**HORIZON®. HRZ-D MANUAL**  
**ADDENDUM**  
June 1980

ADDENDUM to: HRZ-D MANUAL, REVISION\_1

JUNE 4, 1980

HORIZON MOTHERBOARD HRZ-MB-4	SHT
BUFFERS, STATUS, PARALLEL PORTS	4 OF 5

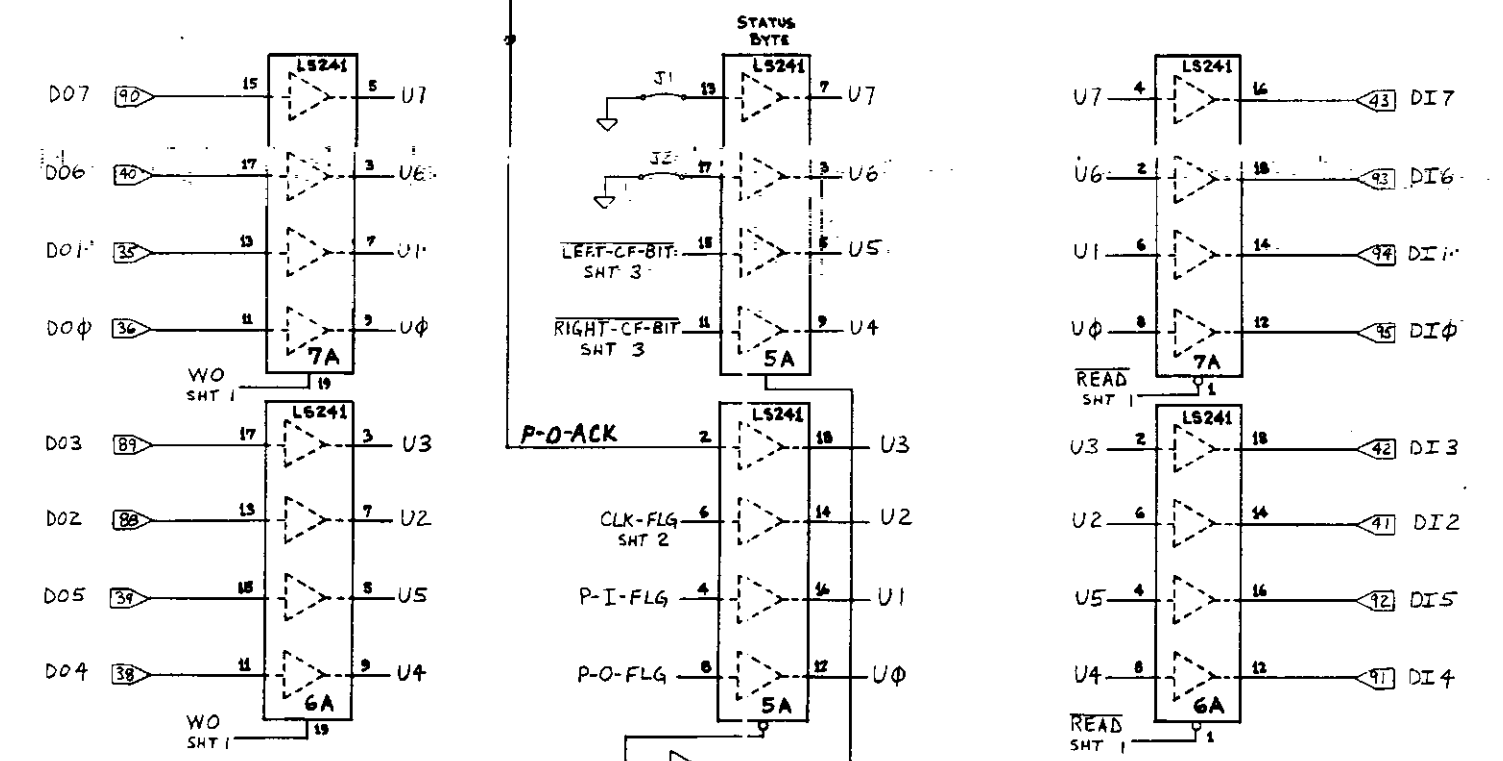
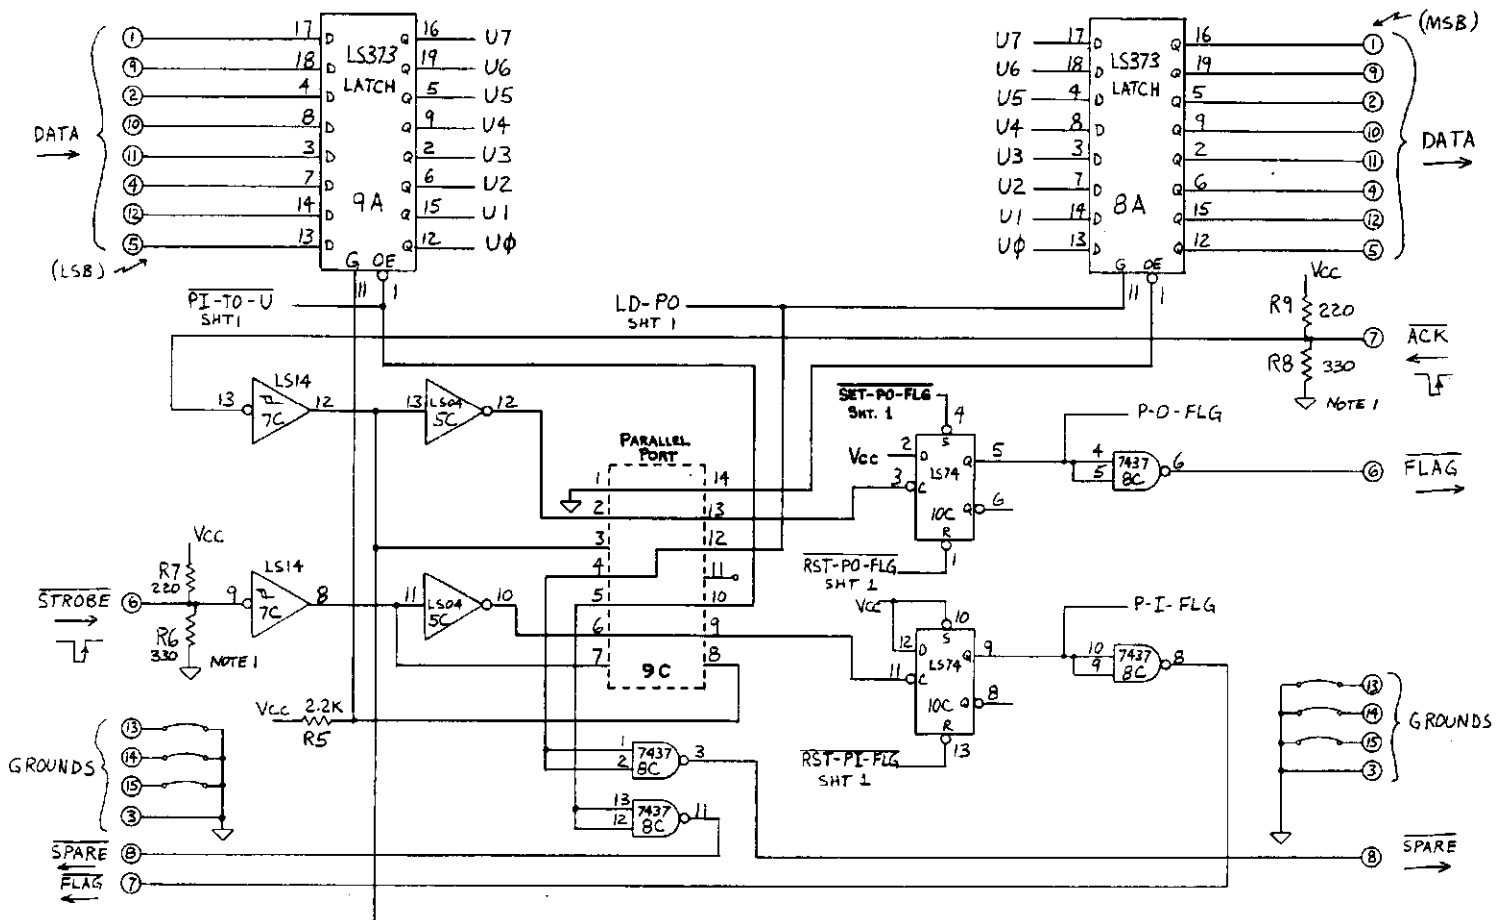
11) For all HORIZON Computer Systems containing motherboards marked "HRZ-MB-4", the following five pages of schematic drawings supersede pages 88, 89, 91, and 92 of the HORIZON Manual.

NOTE 1: R6, R7, R8, R9 ARE OPTIONAL LINE TERMINATORS.

HORIZON CHASSIS/MOTHERBOARD MB-4	SHT
POWER SUPPLIES	50F5
© 1977, NORTH STAR COMPUTERS, INC.

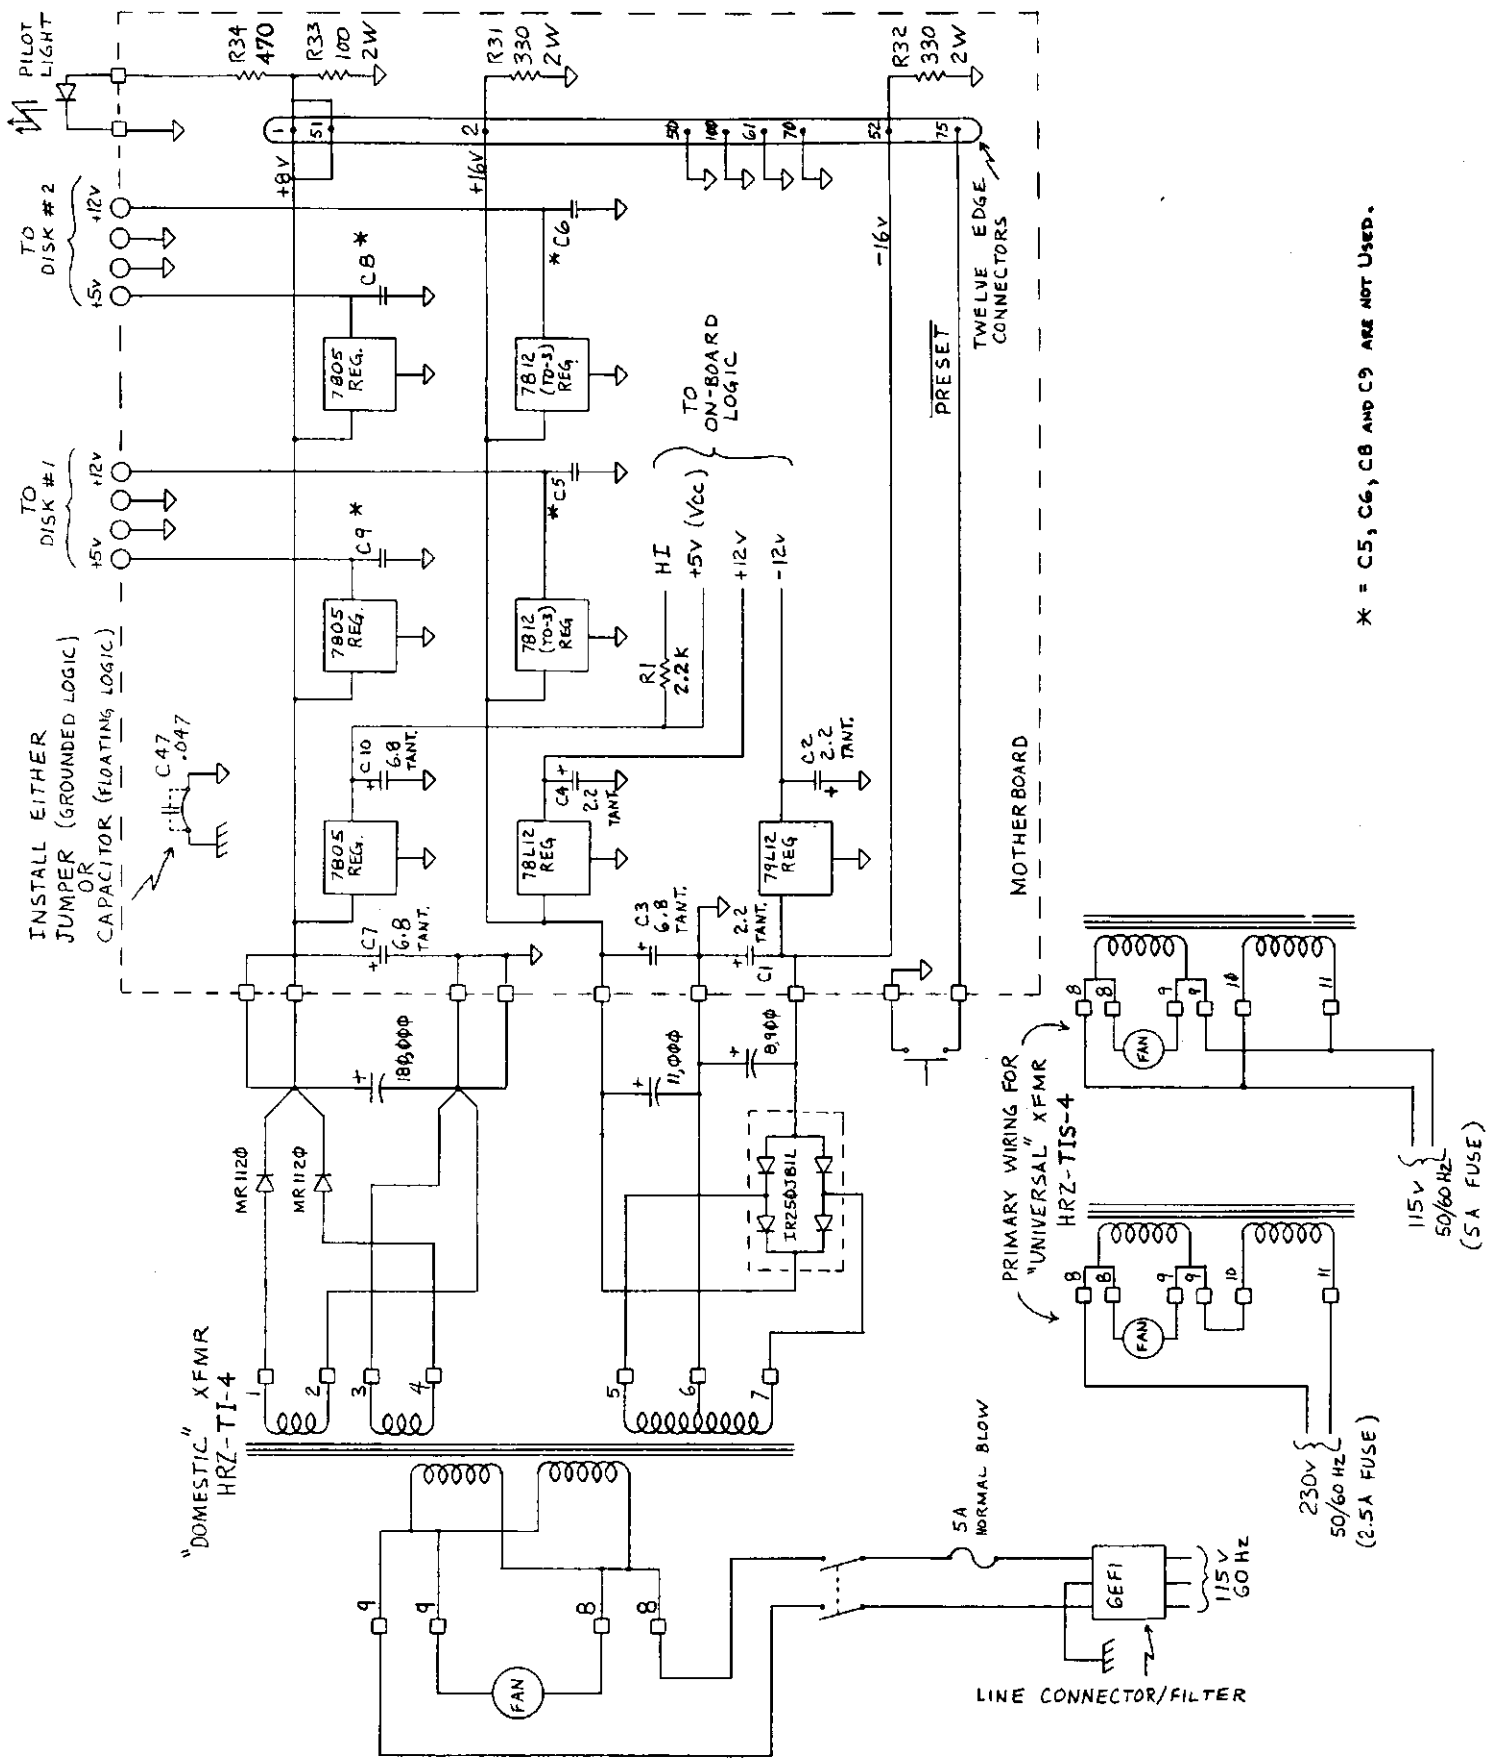
\* = C5, C6, C8 AND C9 ARE NOT USED.
